Historic Preservation Board

Appeal of COA Denial

Case Number: ADM23-00135

November 7, 2023

Proposal's Location

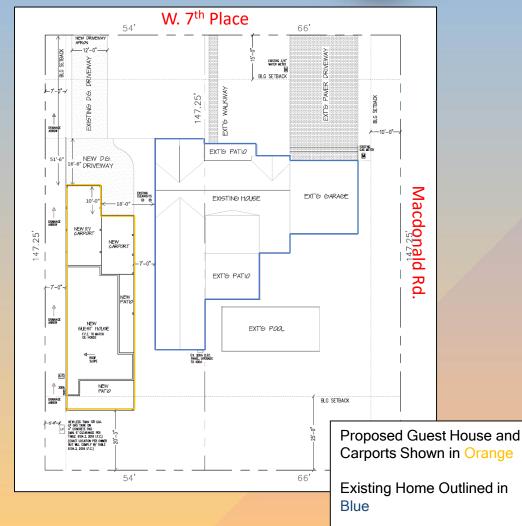
- 7 feet to the west of the existing home
- 51 feet from the front property line
- 7 feet from the side property line
- 20 feet from the rear property line

- Guideline 3 applies to the Proposed Project as "related new construction"
- RV carport is incompatible with Subject Property and NE quadrant of the District
 - Incompatibility could be mitigated if RV carport was not as tall and/or it was moved farther back from front property line
